# Access Compliance Report

## Public Rights-of-Way

Intersection ID: 48391	Main Street: RICHARD_ROZZELLE_DR	Cross Street: JOE_MORRISON_LN	Location: SE
ADA ID: C0655BCEA08D	Ramp Type: BlendTrans1	Initial Pass/Fail: Fail	Overall Compliance: No
		Severity Score: 8.75

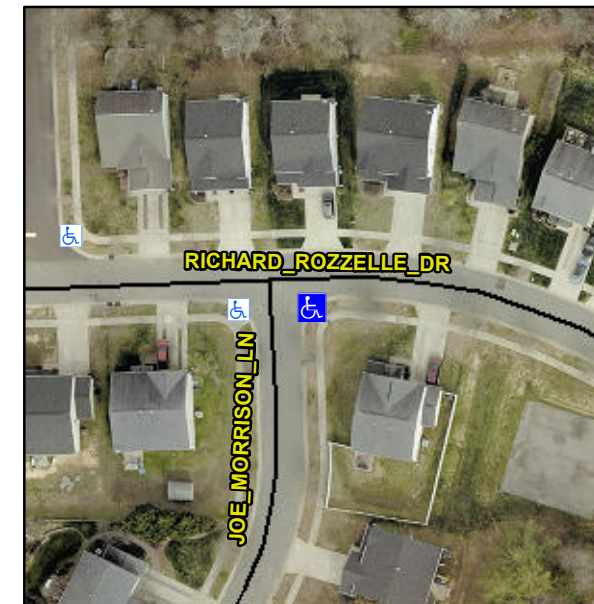
Compliance	Description	Data	Compliance	Description	Data
N/A	Ramp Length (in)	73.0	Yes	BlendTrans Slope (%)	4.5
No	Ramp Width (in)	45.0	Yes	BlendTrans XSlope (%)	1.2
N/A	Flare Type LT	N/A	N/A	Flare Type RT	N/A
N/A	Flare Slope LT (%)	N/A	N/A	Flare Slope RT (%)	N/A
N/A	Flare Traversable LT?	N/A	N/A	Flare Traversable RT?	N/A
N/A	Landing Length (in)	N/A	N/A	DWS Provided?	N/A
N/A	Landing Width (in)	N/A	N/A	DWS Contrast?	N/A
N/A	Landing Slope (%)	N/A	N/A	DWS Length (in)	N/A
N/A	Landing X Slope (%)	N/A	N/A	DWS Full Width?	N/A
N/A	Landing Curb? (Y/N)	N/A	N/A	DWS Offset (in)	N/A
N/A	Shared Landing?	N/A			
N/A	Gutter Ponding?	N/A	N/A	Gutter Slope (%)	N/A
N/A	Gutter Lip Ht (in)	N/A	N/A	Gutter X Slope (%)	N/A
N/A	Painted X Walk1?	No	N/A	Painted X Walk2?	No
	X Walk 1 Direction	To N		X Walk 2 Direction	To W
	X Walk 1 Width (in)	N/A		X Walk 2 Width (in)	N/A
	X Walk 1 Slope (%)	1.1		X Walk 2 Slope (%)	2.0
	X Walk 1 X Slope (%)	1.5		X Walk 2 X Slope (%)	2.5

N/A	Ramp inside XWalk1?	N/A	N/A	Ramp inside XWalk2?	N/A
	Road Slope (%)	0.2		Clear Space?	N/A
	Road X Slope (%)	2.0	N/A	Clear Space to XWalk (in)	N/A
N/A	Any Obstructions?	N/A	N/A	Storm Grate/Utility Hazard?	N/A
	Obstruction Type			Storm Grate/Utility Type	
		N/A			N/A
			Yes	Surface Condition? (G/P)	Good
			N/A	Curb Slope (%)	3.7

**Remove & Replace Curb Ramp With Two New Directional Ramps or Equivalent.**

**R304.5.1**
